CHAPTER 2: COMMENTS RECEIVED AND RESPONSES TO COMMENTS

In accordance with Section 15088 of Title 14 of the California Code of Regulations (the “CEQA Guidelines”), the City of Riverside (City) has evaluated the comments received on the Draft Environmental Impact Report (DEIR) for the Riverside Transmission Reliability Project (RTRP or Proposed Project) and has prepared written responses to these comments. This chapter contains copies of the comments received during the public review process and provides an evaluation of and written responses to each of these comments. Unless otherwise noted, page number references in the responses correspond with the DEIR as published on August 1, 2011; please refer to this document on RPU’s website at <http://www.riversideca.gov/utilities/rtrp-deir.asp>. Revisions made to clarify text in response to a comment can be seen in Volume II of this FEIR.

2.1 COMMENTS RECEIVED

ADDENDUM A
PROPOSED RE-ROUTE
EAST OF SHOPPING CENTER
WEST OF I-15 TOWERS ONLY

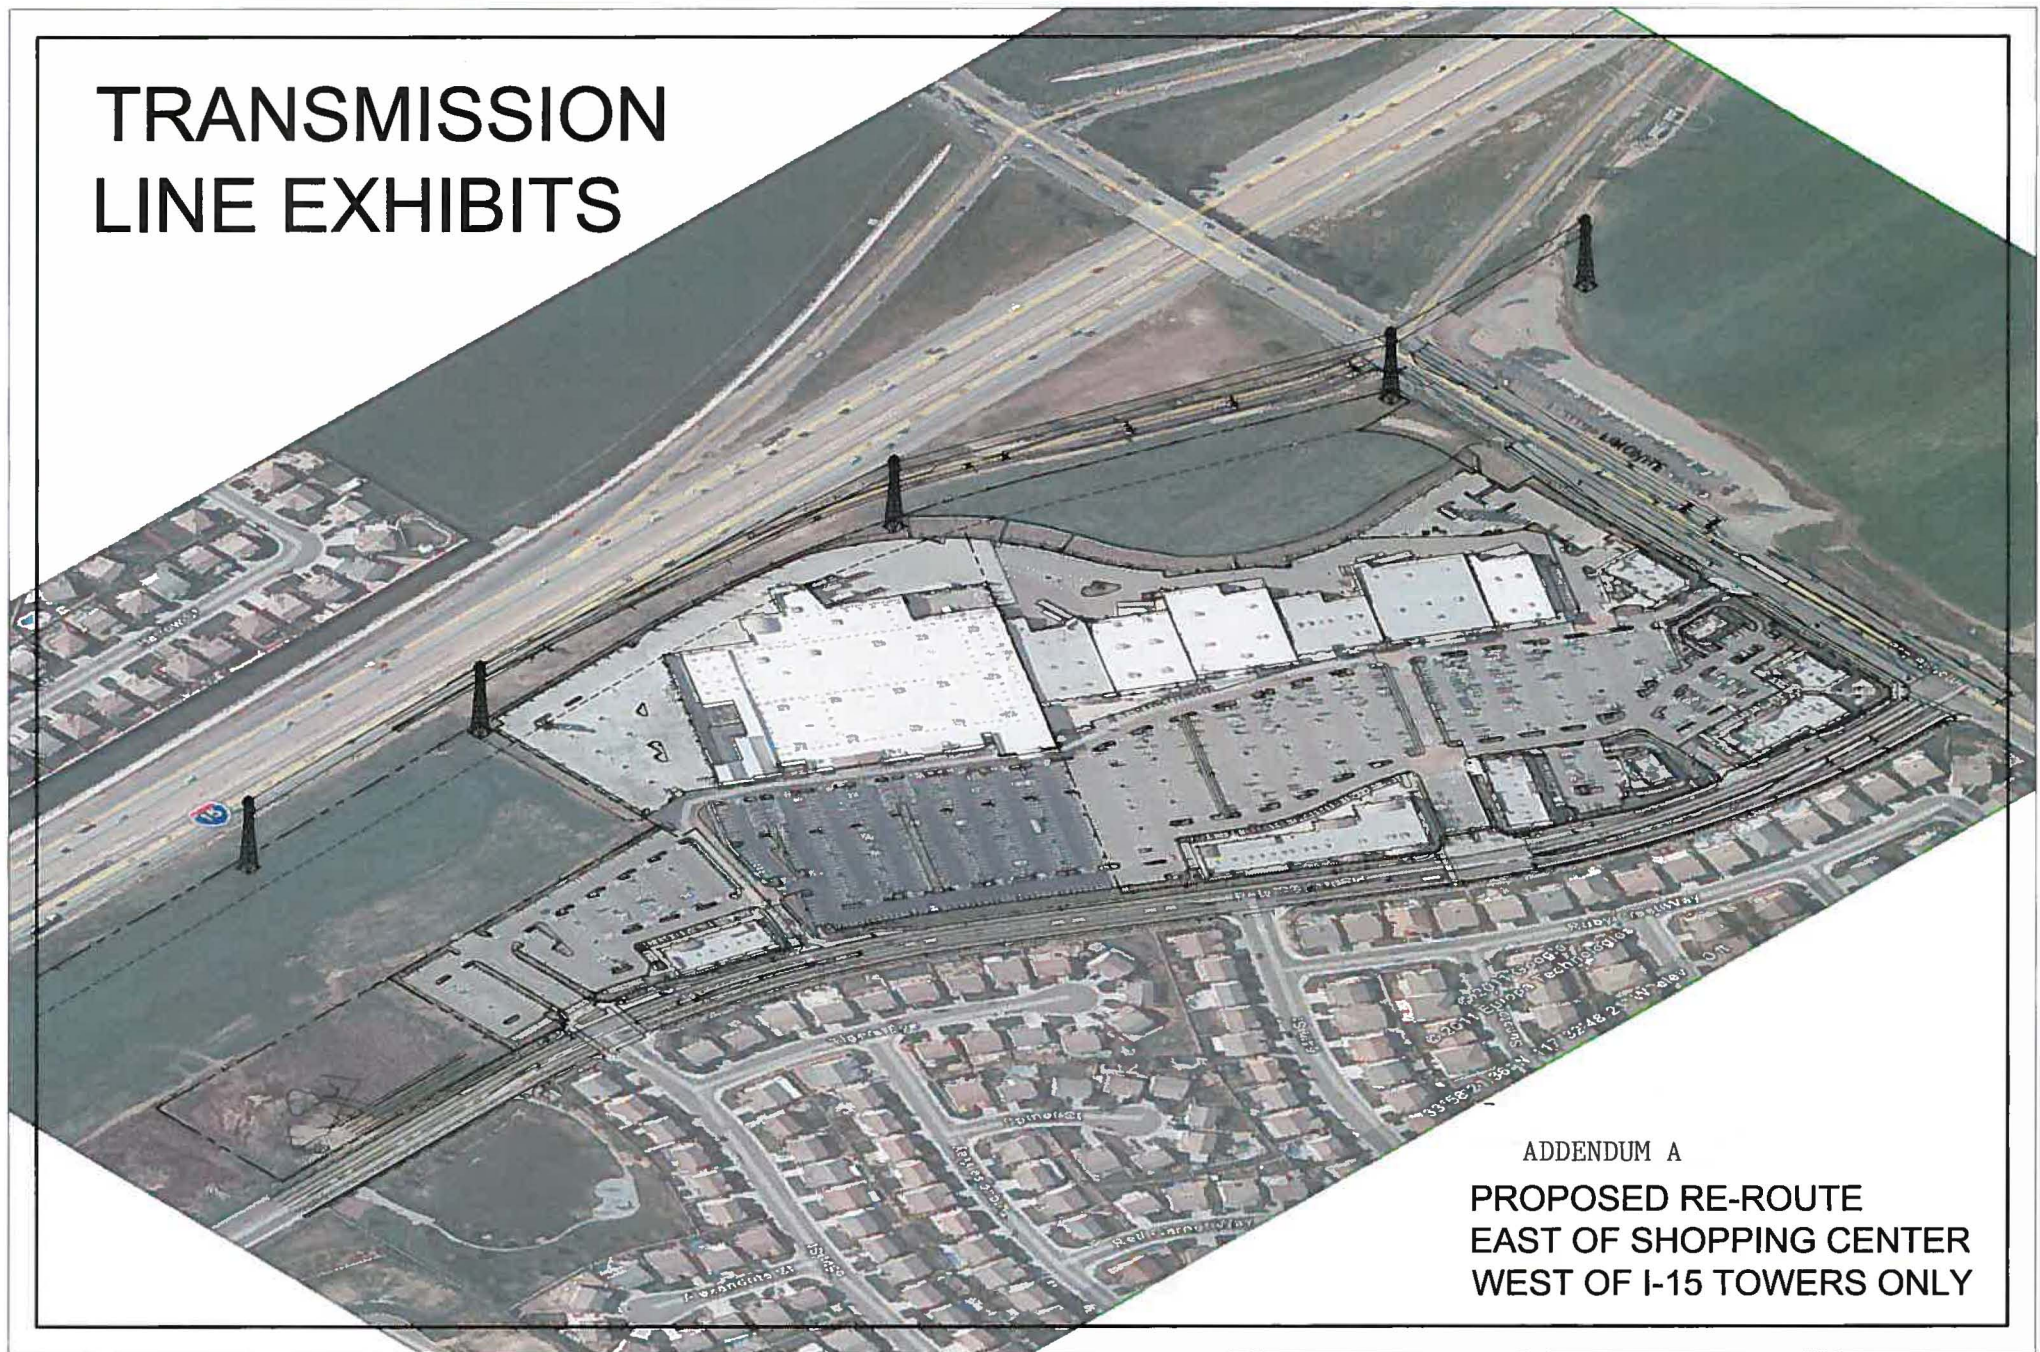
TRANSMISSION LINE EXHIBITS

ADDENDUM B
PROPOSED RE-ROUTE
EAST OF I-15 TOWERS ONLY

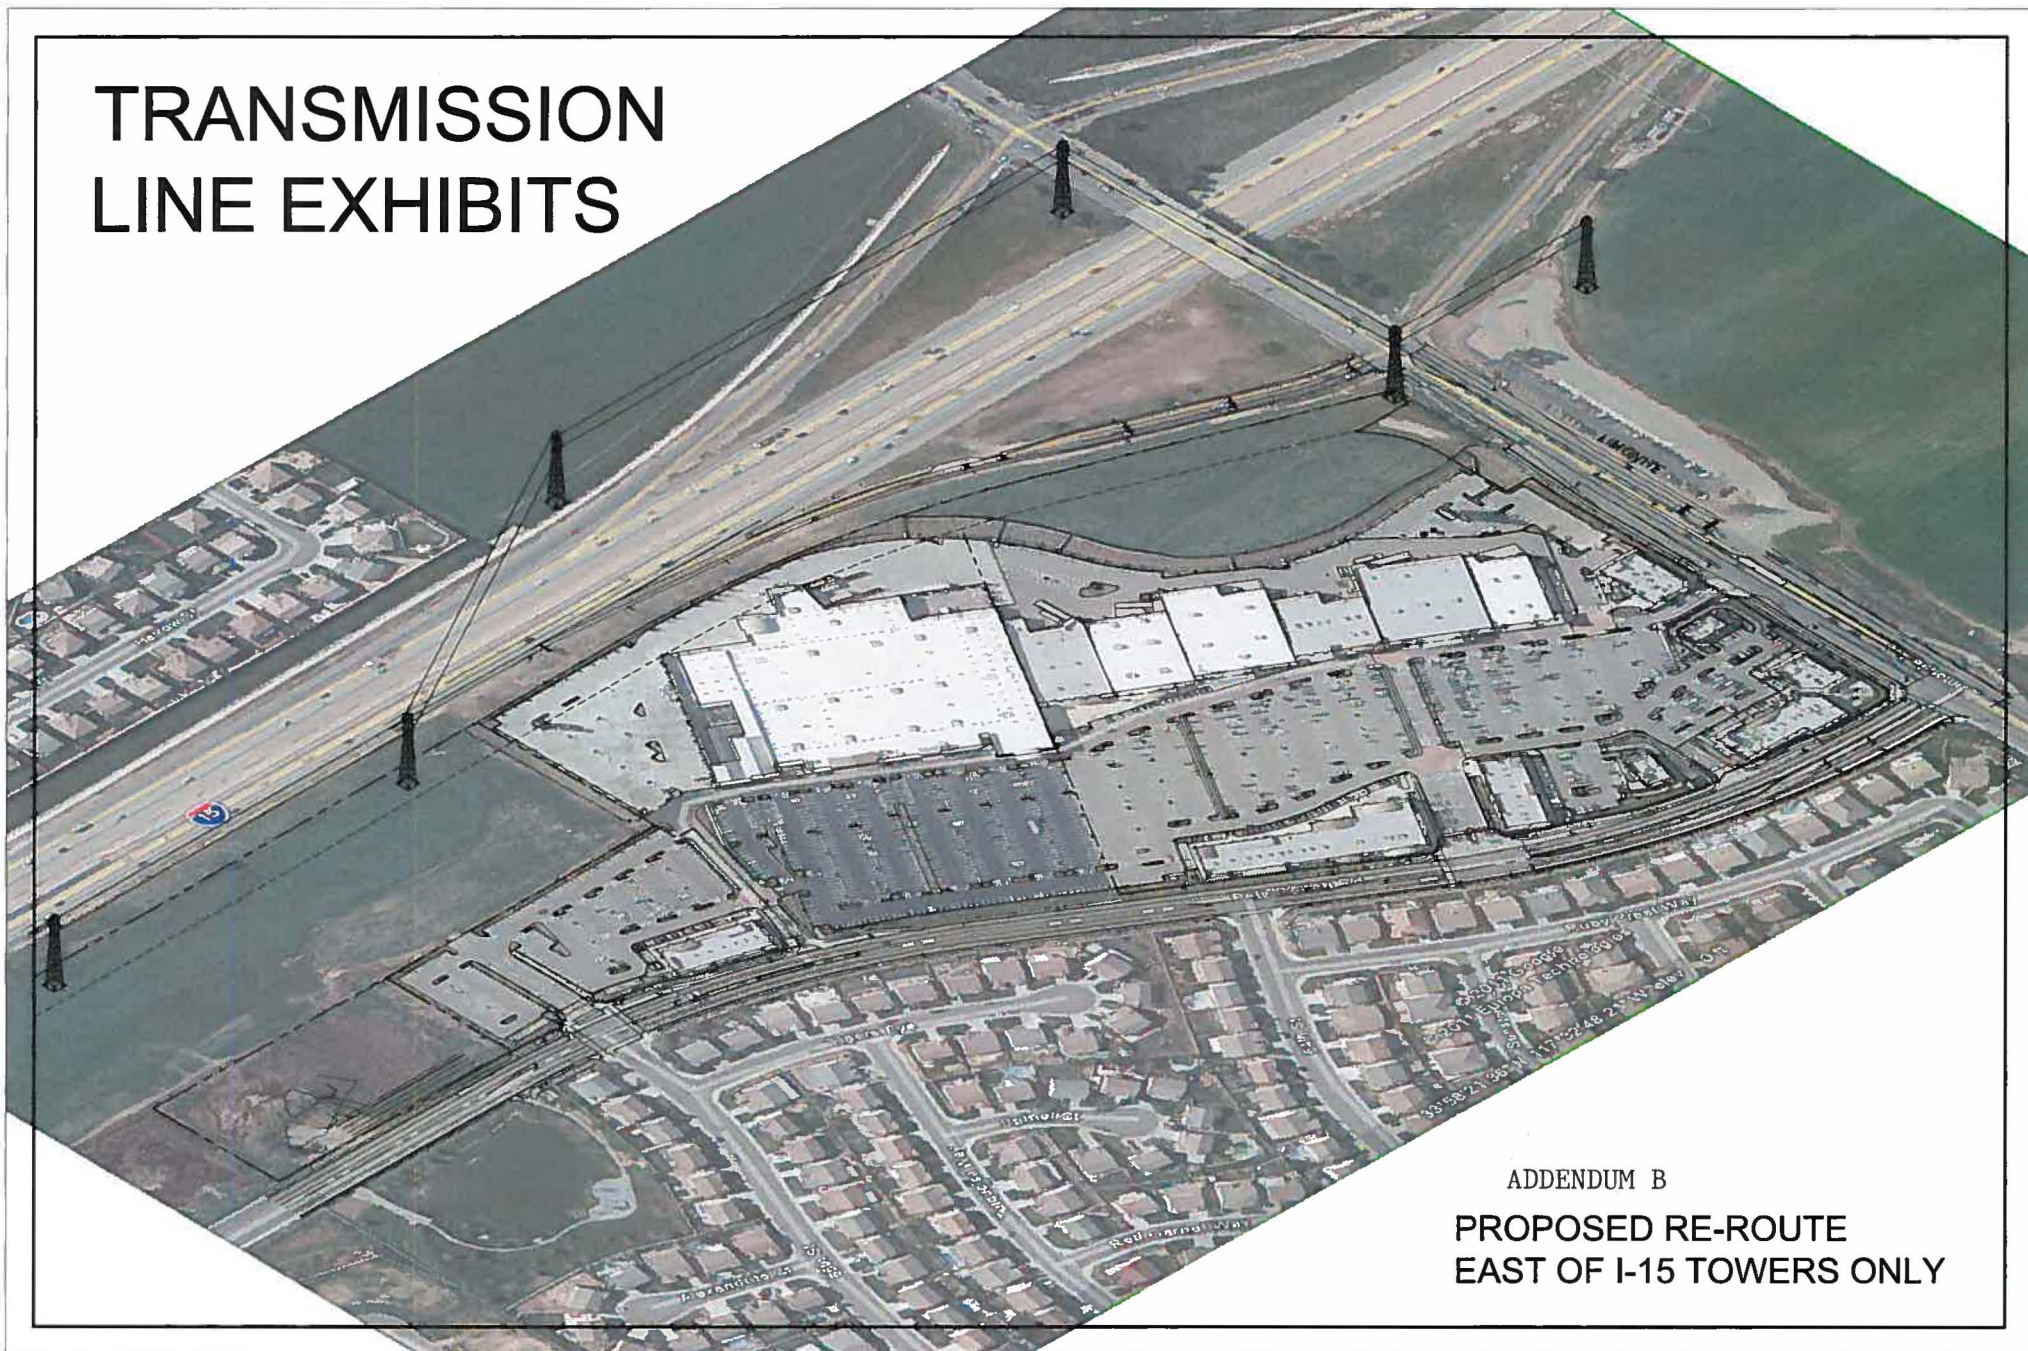
TRANSMISSION LINE EXHIBITS
